UNITED STATES  
NUCLEAR REGULATORY COMMISSION  
WASHINGTON, D. C. 20555

October 22, 1979

SUBJECT: NRC REQUIREMENTS FOR AUXILIARY FEEDWATER SYSTEMS AT MILLSTONE  
NUCLEAR POWER STATION UNIT 2

MILLSTONE 2

Auxiliary Feedwater System  
Millstone 2  
Figure 1

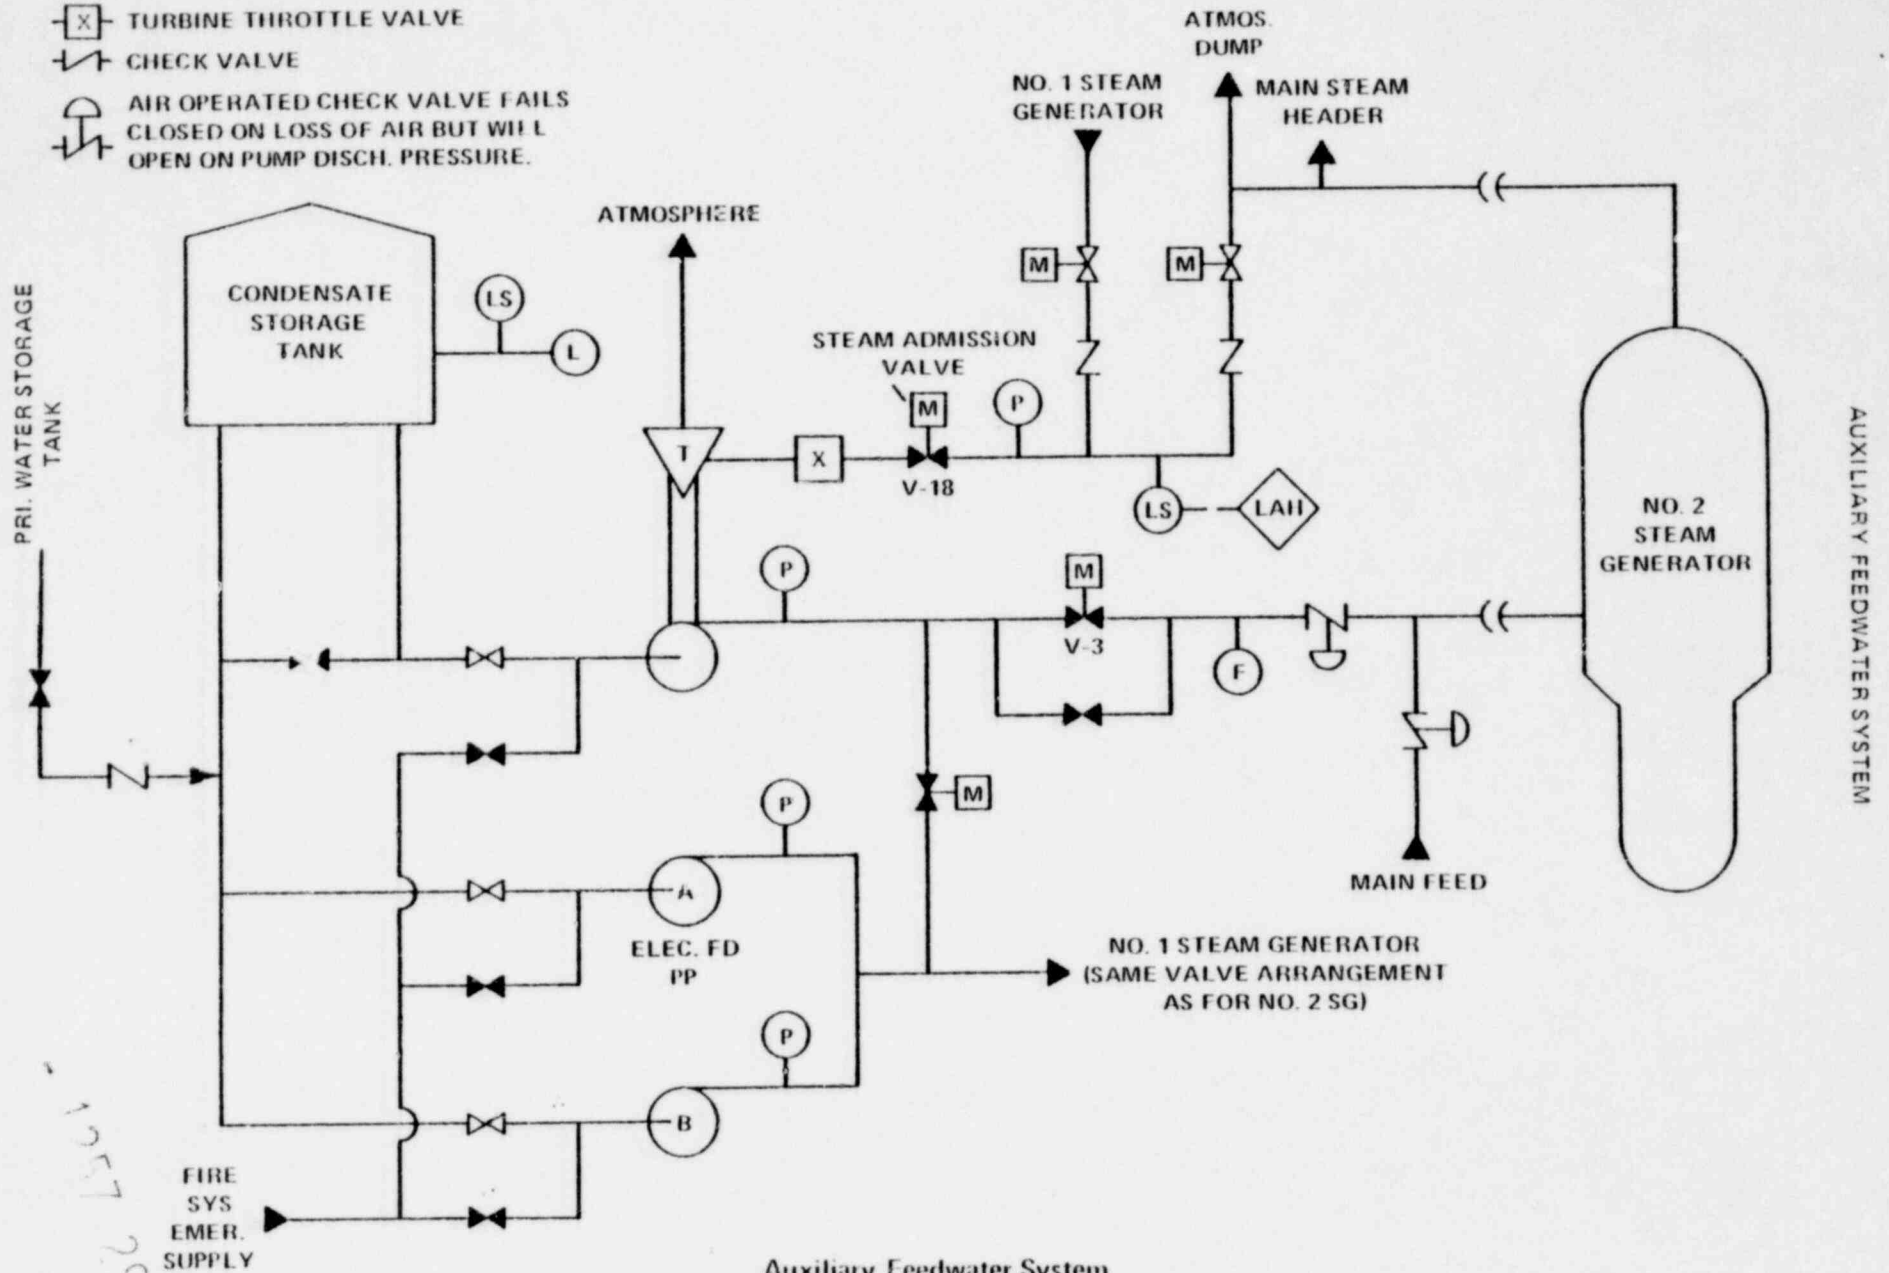
The AFWS is shown in simplified form on Figure 1. The system consists of a steam turbine-driven pump having a 600 gpm capacity, and two motor-driven pumps each having a 300 gpm capacity. The steam supply to the turbine is obtained from a common line connected to lines coming from each of two steam generators. The AFWS is normally aligned as indicated on Figure 1, the motor-driven pumps supplying No. 1 SG and the turbine driven pump supplying No. 2 SG.

The steam for the turbine-driven pump is received from the main steam system via a series of valves as shown in Figure 1. Steam is introduced to the turbine via a normally closed motor operated steam admission valve, and steam flow is regulated by a turbine throttle valve in series with the admission valve.

The dominant failure mode for this event is failure of the operator to manually open two normally closed valves (the steam admission valve and the AFW discharge valve) in the turbine-driven train within the aforementioned 15 to 45 minutes after the demand. The valves are AC motor-operated and are normally powered from offsite power or from the diesel-generators on loss of offsite AC power. Since neither of these power sources is available during this event, local manual opening of the valves is required.

The second significant dependency found is the dependence on AC power to actuate certain portions of the steam-driven pump train of the AFWS. This dependency is the dominant contributor to AFWS unavailability upon the total loss of AC power.

2. Recommendation GS-5 - The plant should be capable of providing the required AFW flow for at least two hours from one AFW pump train independent of any alternating current power source. If manual AFW system initiation or flow control is required following a complete loss of alternating current power, emergency procedures should be established for manually initiating and controlling the system under these conditions. Since the water for cooling of the lube oil for the turbine-driven pump bearings may be dependent on alternating current power, design or procedural changes shall be made to eliminate this dependency as soon as practicable. Until this is done, the emergency procedures should provide for an individual to be stationed at the turbine-driven pump in the event of the loss of all alternating current power to monitor pump bearing and/or lube oil temperatures. If necessary, this operator would operate the turbine-driven pump in an on-off mode until alternating current power is restored. Adequate lighting powered by direct current power sources and communications at local stations should also be provided if manual initiation and control of the AFW system is needed. (See Recommendation GL-3 for the longer-term resolution of this concern.)

4. Recommendation GS-8 - The licensee should install a system to automatically initiate AFW system flow. For the short-term, this system need not be safety-grade; however, it should meet the criteria listed below, which are similar to Item 2.1.7a of NUREG-0578. For the longer term, the automatic initiation signals and circuits should be upgraded to meet safety-grade requirements as indicated in Recommendation GL-1.

2. Recommendation - GL-3 - At least one AFW system pump and its associated flow path and essential instrumentation should automatically initiate AFW system flow and be capable of being independently of any alternating current power source for at least two hours. Conversion of direct power to alternating current is acceptable.
